Product / Process Change Notification (PCN)

PCN #: PCN_IndGF_20210201

Affected Series: WE-GF; 744764xxx; 744766xxx

Classification Reflow Profile for SMT components:

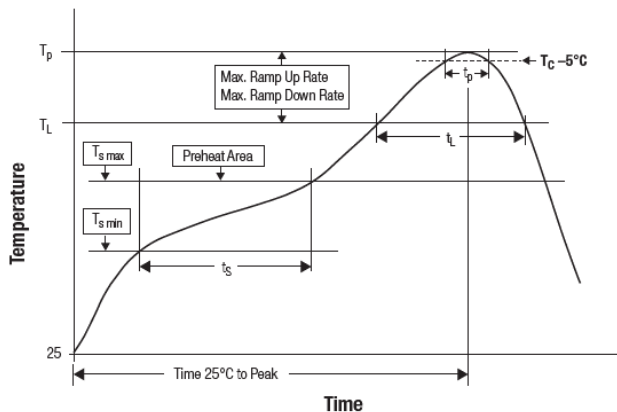
The samples are tested with a peak temperature at the reflow soldering of 250°C according to IPC/ JEDEC J-STD-020E.

Profile Feature		Value
Preheat Temperature Min	$T_{s \text{ min}}$	150 °C
Preheat Temperature Max	$T_{s \text{ max}}$	200 °C
Preheat Time t_s from $T_{s \text{ min}}$ to $T_{s \text{ max}}$	t_s	60 - 120 seconds
Ramp-up Rate (T_L to T_p)		3 °C/ second max.
Liquidous Temperature	T_L	217 °C
Time t_L maintained above T_L	t_L	60 - 150 seconds
Peak package body temperature	T_p	250°C max.
Time within 5 °C of actual peak temperature	t_p	20 - 30 seconds
Ramp-down Rate (T_L to T_p)		6 °C / second max.
Time 25 °C to peak temperature		8 minutes max.
